Subject: Duke Energy Corporation
Oconee Nuclear Station - Units 1, 2, and 3
Docket Nos. 50-269, 50-270, and 50-287

Revisions to Topical Report DPC-NE-3003 In Support of
Steam Generator Replacement
Response to NRC Staff Request for Additional
Information

Duke Power Response To Request For Additional Information

DPC-NE-3003 Revision 1 “Mass and Energy Release and Containment Response Methodology”

GOTHIC 7.0 - FATHOMS COMPARISON

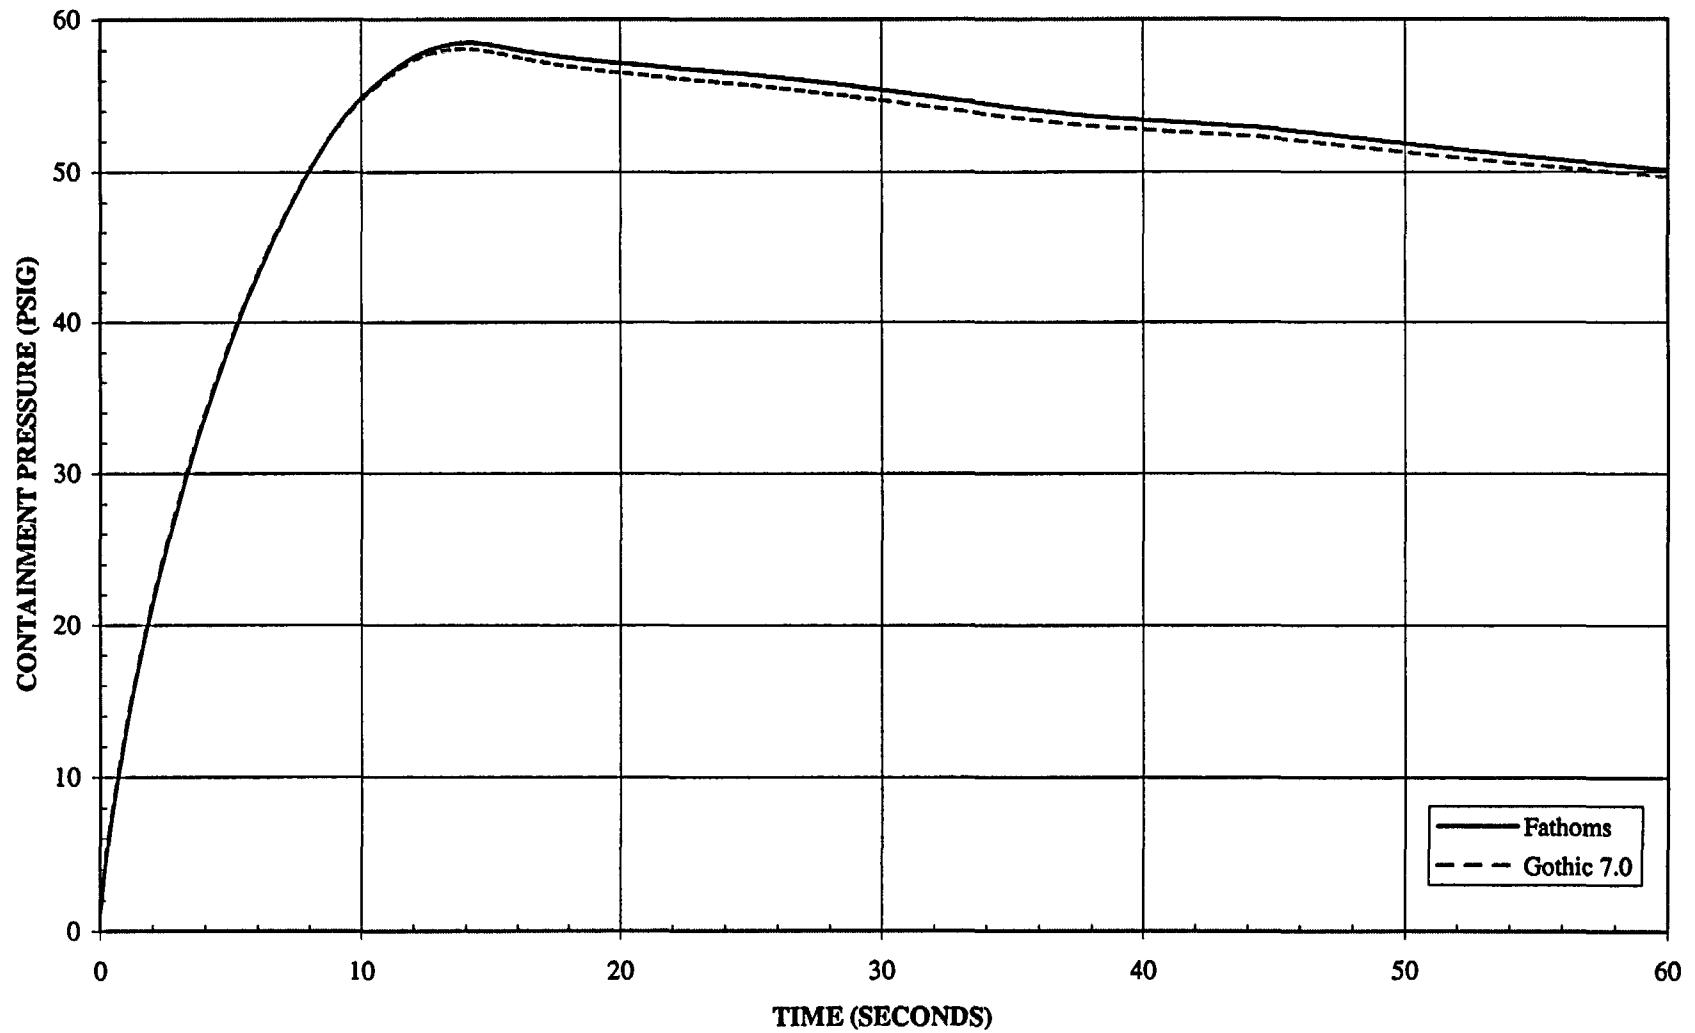
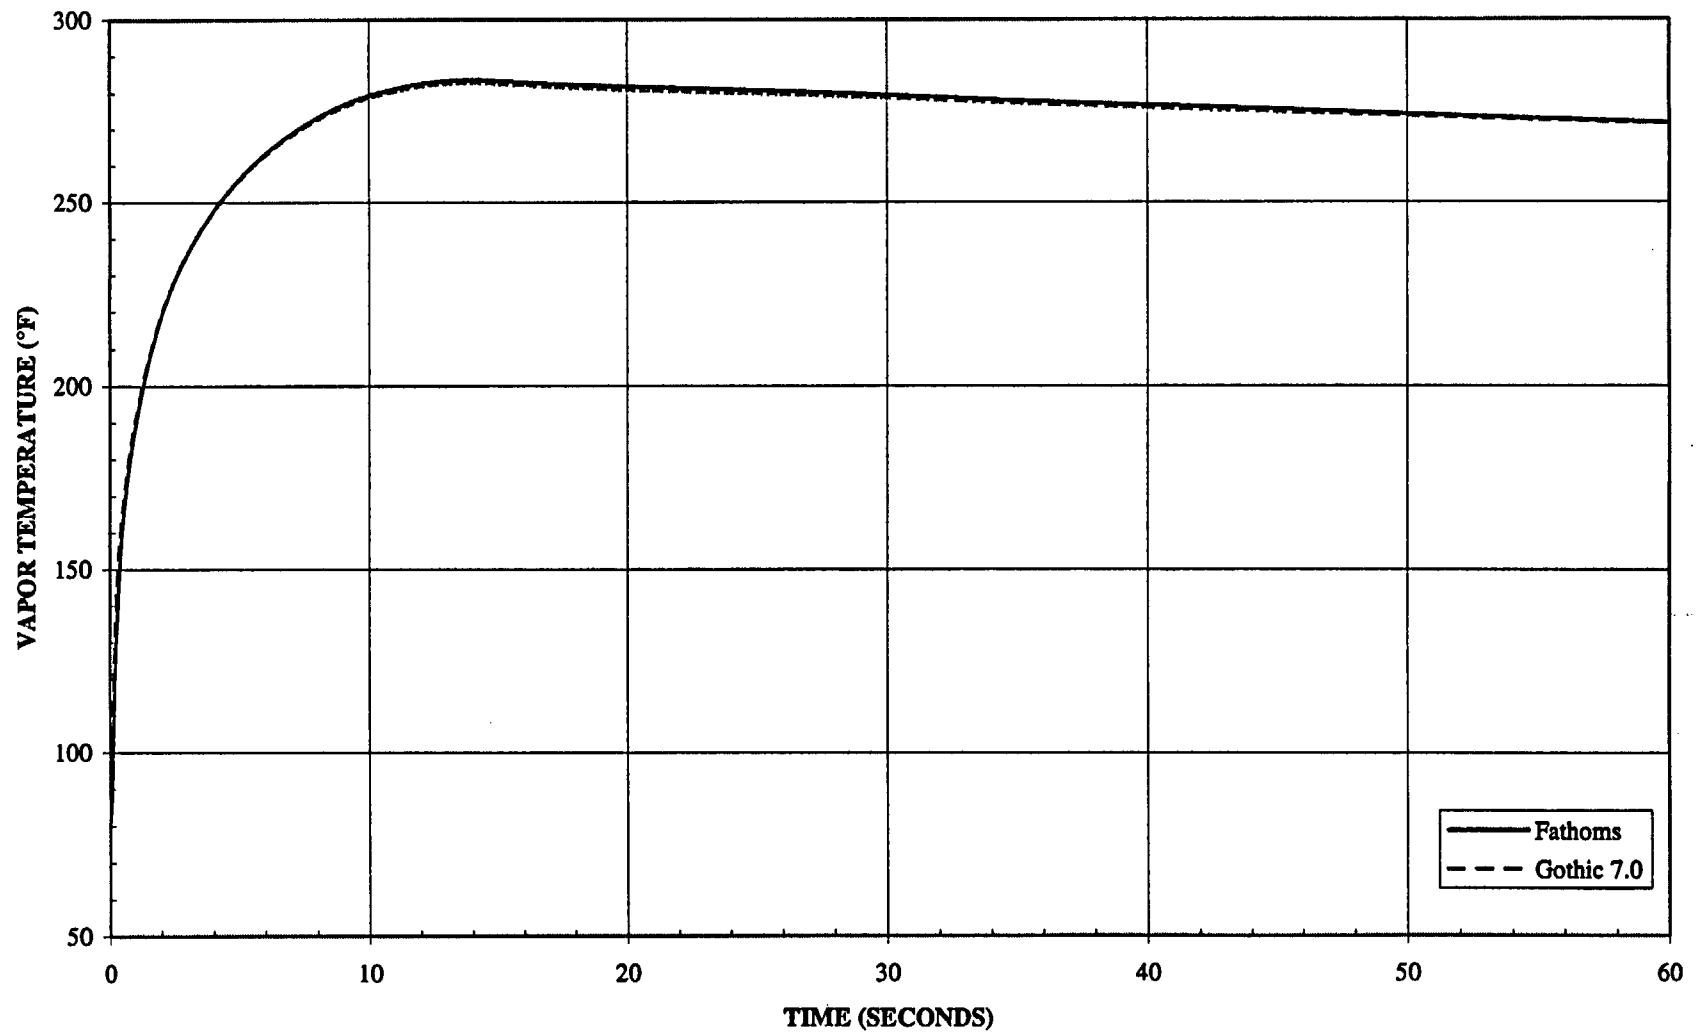
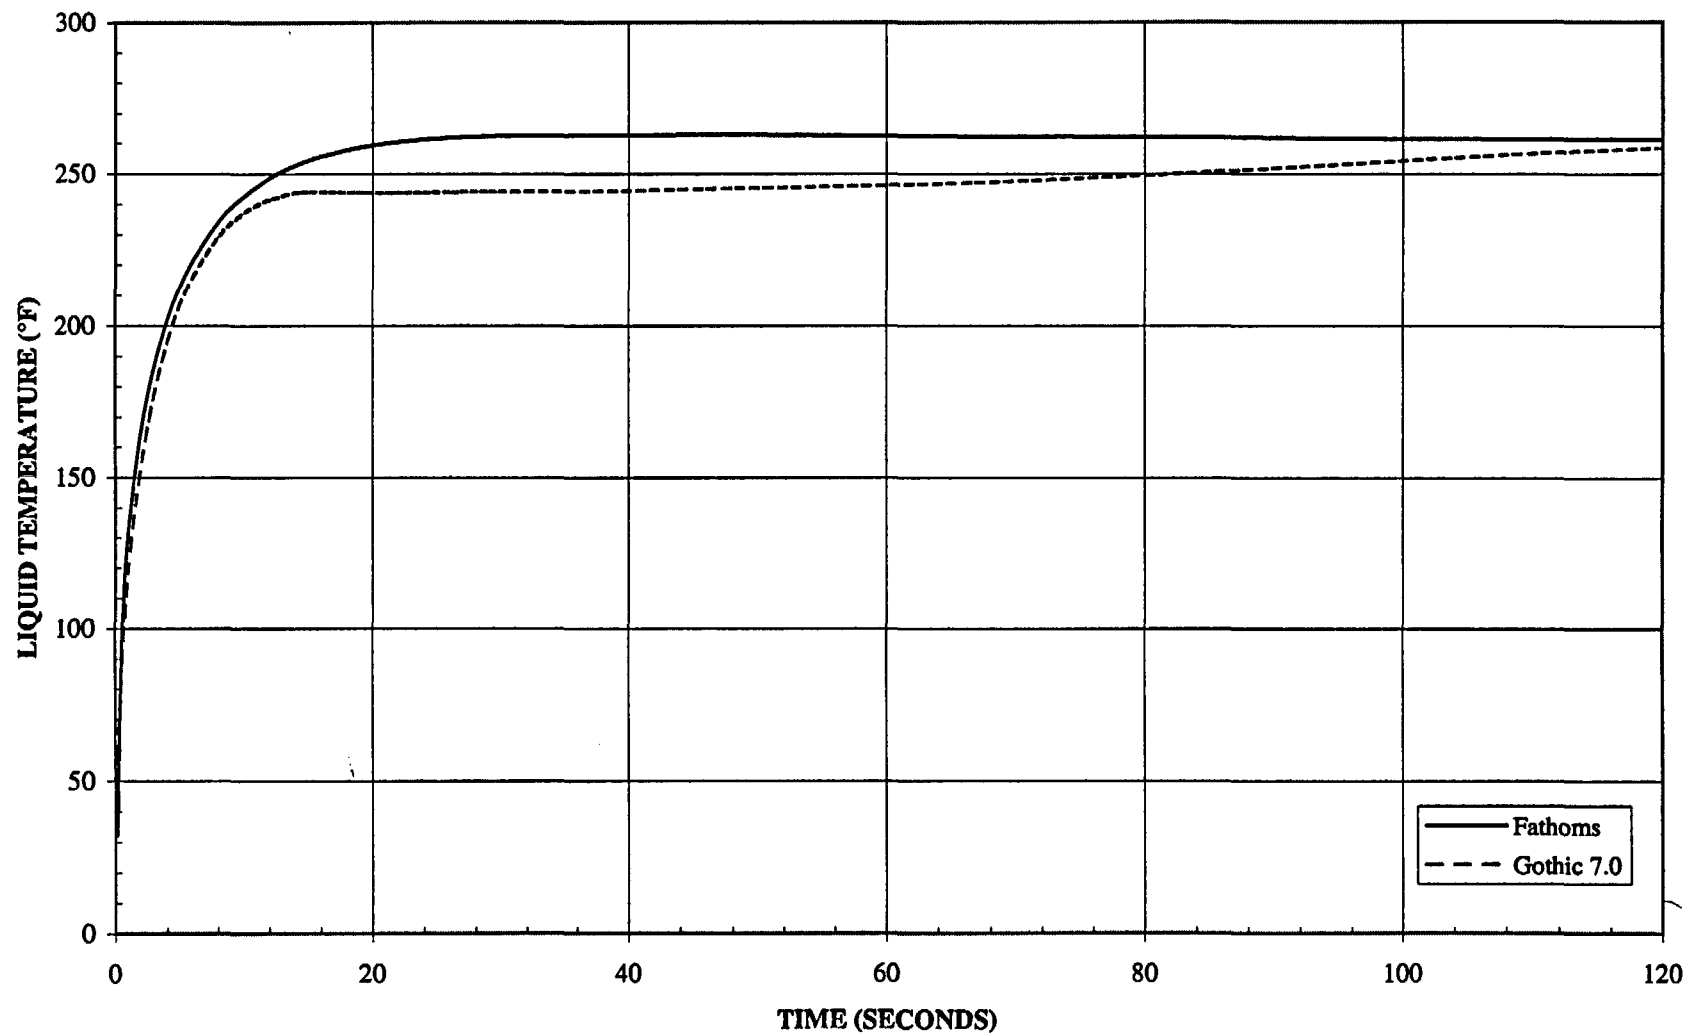
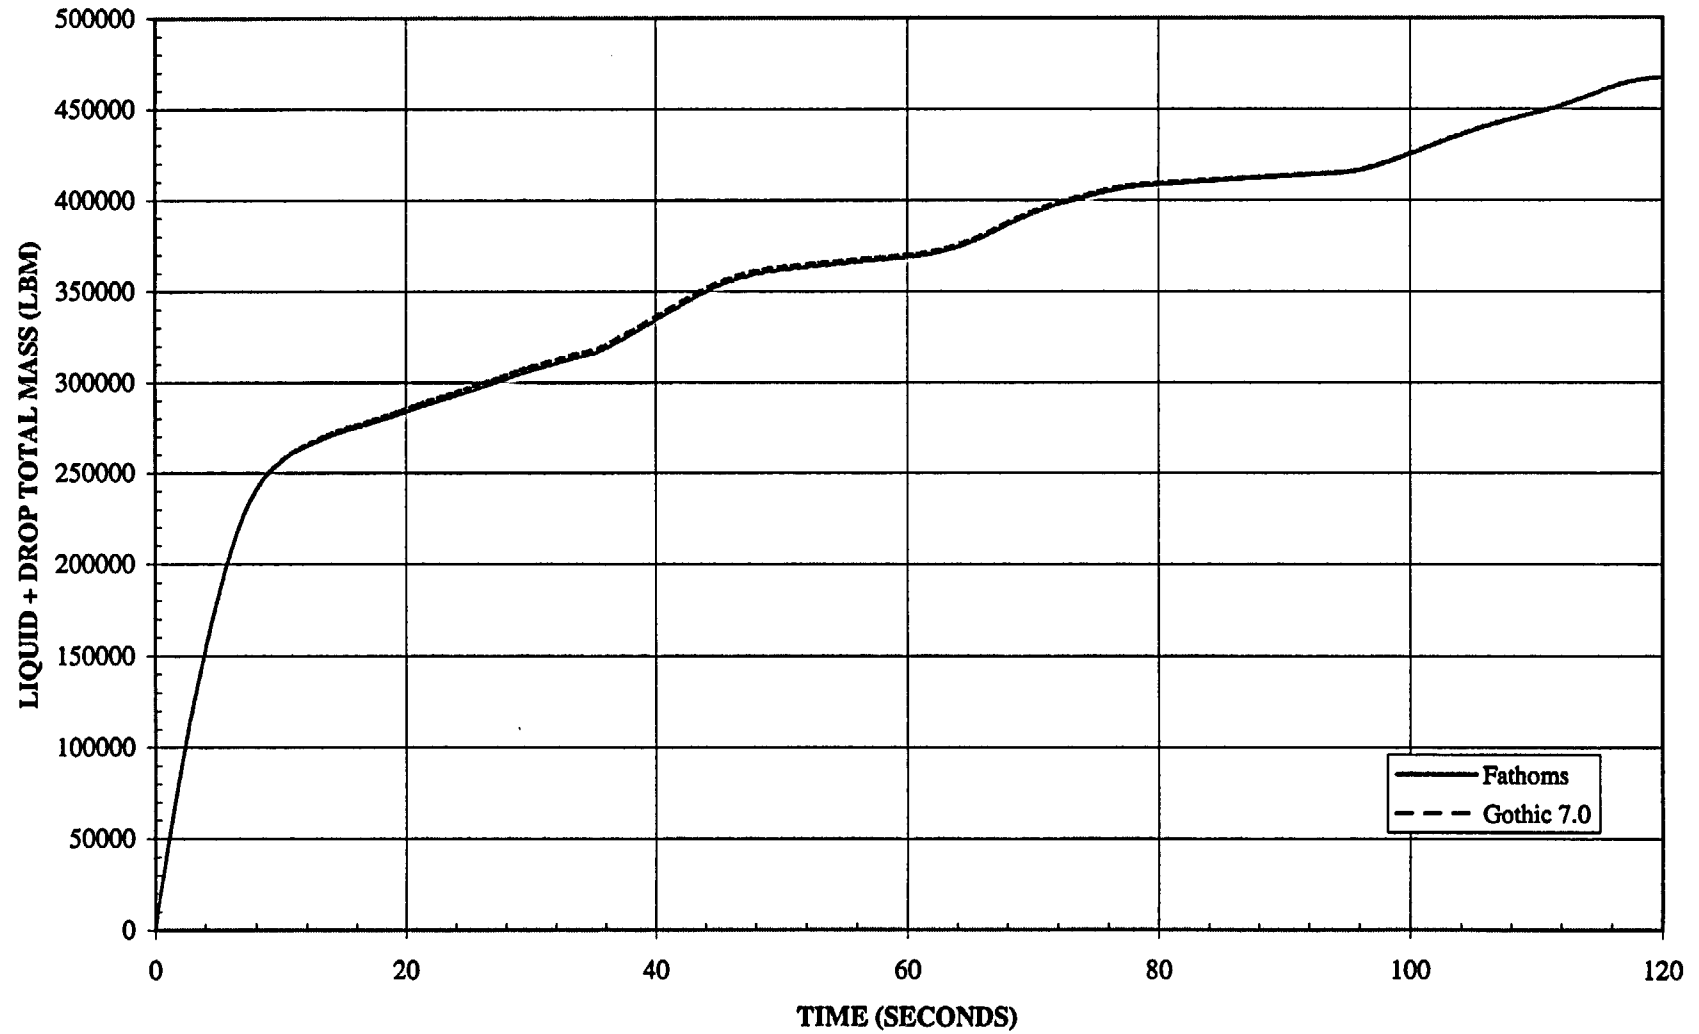
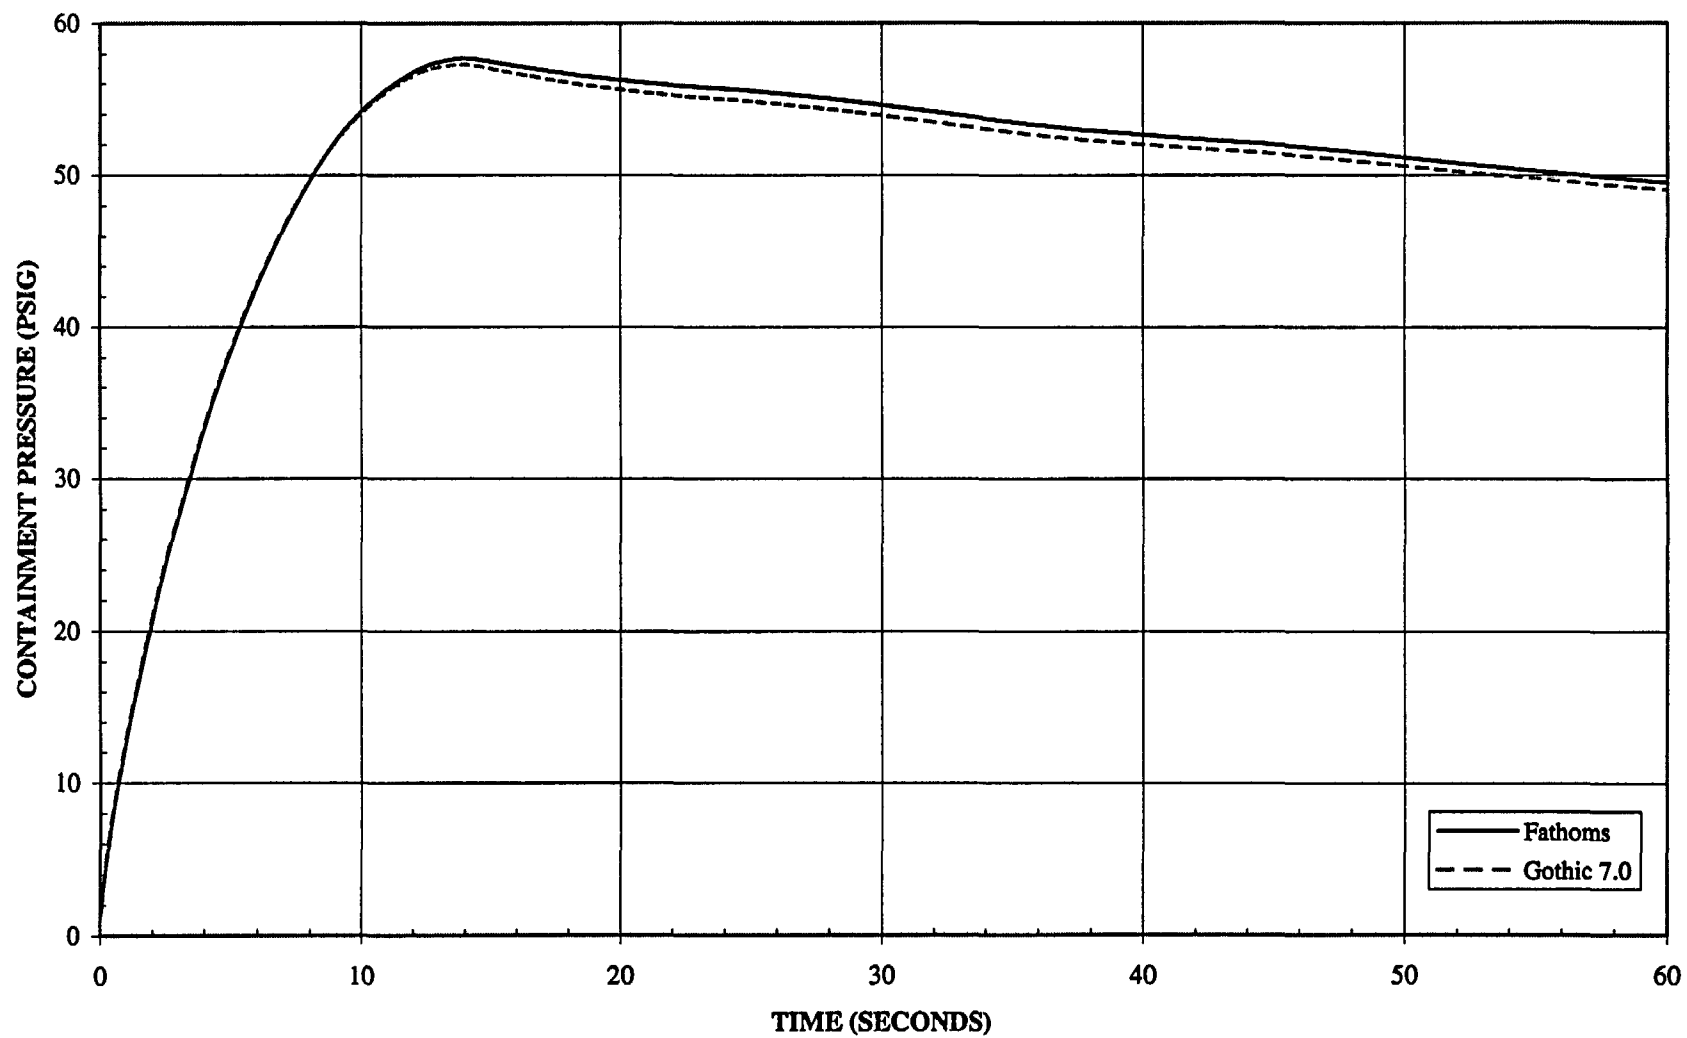
3. Please provide the results using the GOTHIC 7.0 code of peak pressure and temperature calculations for the sensitivity cases listed in Table 3.1-1 of DPC-NE-3003 in tabular and graphical form. If the results or conclusions are significantly different from those presented in DPC-NE-3003P, explain the difference.

Response: Table 3.1-1 of DPC-NE-3003 describes a spectrum of LOCA peak pressure cases including a range of break locations and sensitivity analyses for several important modeling assumptions. The staff's request is understood to focus on the difference in the predicted results from the FATHOMS and GOTHIC 7.0 code versions. Rather than show the comparison for the cases in Table 3.1-1, a different set of cases has been selected which is more focused on the current knowledge of the key sensitivity parameters. Also, the results presented are for the ROTSGs, which is the subject of Revision 1 to the topical report.

The results of the 14 code comparison analyses are shown in Table 3-1 below and in the figures that follow. In general, the pressure and vapor temperature response predictions were very similar in both magnitude and trend. GOTHIC 7.0 predictions for peak pressures and vapor temperature were slightly lower (~0.5 psig and 0.5°F). These differences are consistent with the code model differences described in the response to Question #1. Both codes predict a saturated containment atmosphere due to the large amount of drops injected. The slightly lower pressure, vapor temperature, and liquid temperature from GOTHIC 7.0 may be attributed to additional drop hold up in the atmosphere. This effectively increases the heat capacity of the atmosphere and reduces the temperature rise for a given energy addition. A comparison of the total liquid and drop masses, and liquid temperatures, show the predictions of the two codes to be essentially the same. This is consistent with the changes in the drop deposition and entrainment models discussed in Question #1. These results show that the two code versions give essentially similar results for the same break location and initial and boundary conditions.
